**REQUEST FOR INFORMATION
FOR
COUNTY OF SAN MATEO**

**SLIP-OUT REPAIR AND BANK STABILIZATION NEAR 1780 HIGGINS CANYON
ROAD**

**COUNTY PROJECT NO. 08H17
PROJECT FILE NO. E5082**

4 **CONCRETE LAGGING**
NOT TO SCALE

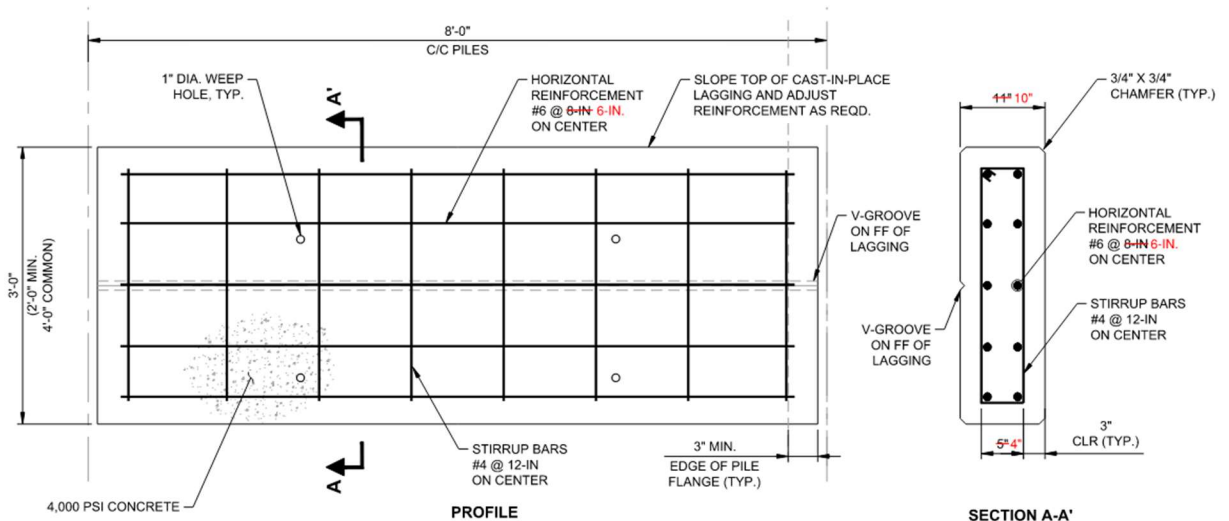
Q19 Drawing C-401 specifies a HP12x84 steel pile and Section 4 of Drawing shows a 11" concrete lagging width. These sizes are not compatible. The distance between the inner edges of the flanges is less than 11". Additionally, the retaining wall plan on Drawing C-200 shows a curved wall. If the lagging is not at a 90 angle to the pile web (straight wall), then the thickness of the lagging that can fit within the pile flanges will need to be reduced even more.

R19 To account for a reduction in allowable thickness due to the flange spacing (approximately 10.9") and the curvature of the wall, the Contractor may reduce the lagging thickness where required to 10" provided 3" of clear space is still provided between the concrete face and the rebar cage, and the horizontal reinforcement is reduced to 6" spacing instead of 8" spacing. Please see detail below.
